**Economic and Social Council**Distr.: General
20 September 2022

World Forum for Harmonization of Vehicle Regulations**Working Party on Passive Safety****Seventy-second session**

UN Regulation No. 100 (Electric power trained vehicles)**Proposal for Supplement 3 to the 03 Series of Amendments to
UN Regulation No. 100 (Electric power trained vehicles)****Submitted by the expert from the International Association of the Body
and Trailer Building Industry ***

Figure 3
Marking of vehicles of category O: Use of wheel chocks

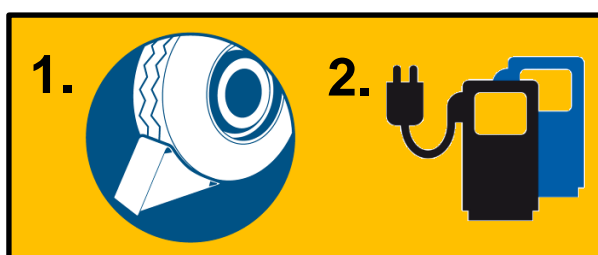
In the case of vehicles of category O, the vehicle shall provide an audible warning if any vehicle movement is detected, and movement shall be impeded by the use of wheel chocks. A visual instruction shall be made visible by a symbol shown in Figure 3 near the vehicle inlet.

13. **Paragraph 5.3.3. and new figure 3:** In cases when the trailer REESS is charged externally the trailer shall provide an audible warning if a trailer movement is detected. Furthermore an instruction to use wheel chocks is to be placed on a label near the trailer inlet.

Figure 1
Generic Description of Test Pulses

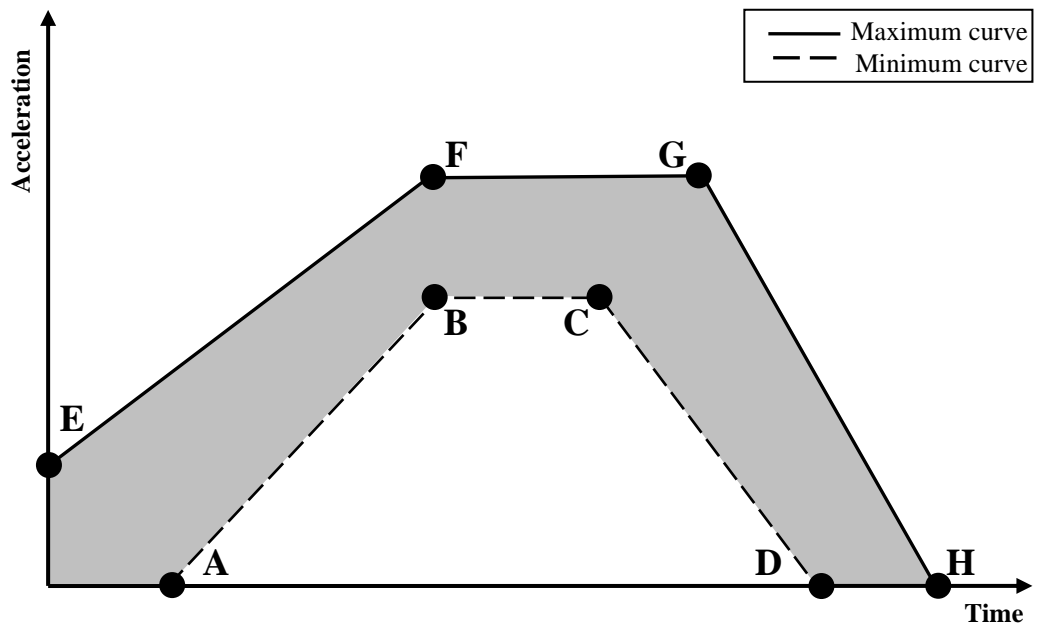
The Tested-Device shall be decelerated or accelerated in compliance with the acceleration corridors which are specified in Tables 1 to 3. The manufacturer shall decide whether the tests shall be conducted in either the positive or negative direction or both.

The test pulse shall be within the minimum and maximum value as specified in Tables 1 to 3. A higher shock level and /or longer duration as described in the maximum value in Tables 1 to 3 can be applied to the Tested-Device if recommended by the manufacturer.

15. **Annex 9C Mechanical shock Paragraphs 3.2.:** The resistance against mechanical shock focuses on pulses of crash tests or similar performance tests of vehicles of categories N1, N2, N3, M1, M2 and M3. Trailers are normally not in the scope of crash test regulations due to the absence of passengers. Therefore it is recommended to define basic performance pulses for trailers in relation to the category of the trailer. REESS on O1/O2 may be tested with the pulse as defined for N3. REESS for O3/O4 may be tested with a pulse related to requirements about the ADR ("Agreement concerning the International Carriage of Dangerous Goods by Road " – Transport of dangerous goods) UNECE.
